#### SHIRE OF DENMARK

#### HORSLEY/ROCKFORD ROAD LOCAL STRUCTURE PLAN

## Shire of Denmark Town Planning Scheme No. 3 Amendment No. 119 Schedule of Submissions

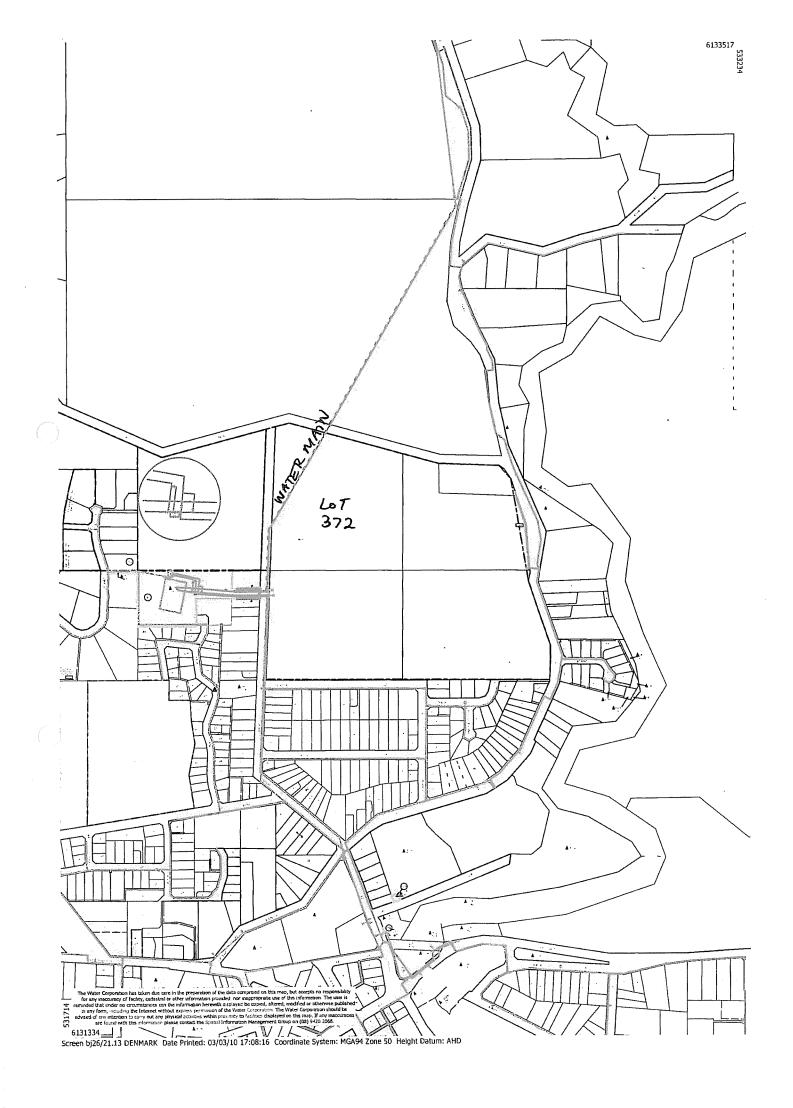
While the land can be connected to the Water Corporation's water supply scheme in the future, the water distribution and source capacity in the area is currently insufficient to service the proposed subdivision and development indicated on the Subdivision Guide Plan accompanying the amendment.

A major water transfer main currently traverses the north-west portion of Lot 372 (see attached diagram). Water mains must be adequately protected within road reserves or public open space and cannot be located within private residential properties for safety reasons. The location of the water main is indicated on Appendix 4 ("Site Characteristics" plan) but has not been reflected on the Local Structure Plan accompanying the amendment. The Structure Plan must be modified prior to subdivision and in consultation with the Water Corporation to provide adequate, ongoing protection for the water main.

The Water Corporation has conducted wastewater scheme planning for the locality. The sewerage planning for this area divides the subject land into two sub-catchments, roughly east and west of the north-south common boundary between Lots 372 & 366 and Lots 51 & 365.

Wastewater generated in the western sub-catchment will gravitate to a 225mm diameter sewer that will need to connect to the existing sewer in Rushton Street to the south of the site. Wastewater generated in the eastern sub-catchment will gravitate to the east and south and will connect to an existing sewer in Rushton Road near the south-eastern corner of Lot 365. The routes for the required sewers must be adequately accommodated within road reserves through the development area.

The developers of this land will be required to provide and fund all water and sewerage reticulation and to pay headworks contributions at the subdivision stage. New works and the upgrading of existing works may also be required to cater for the demand generated by the development of this land.
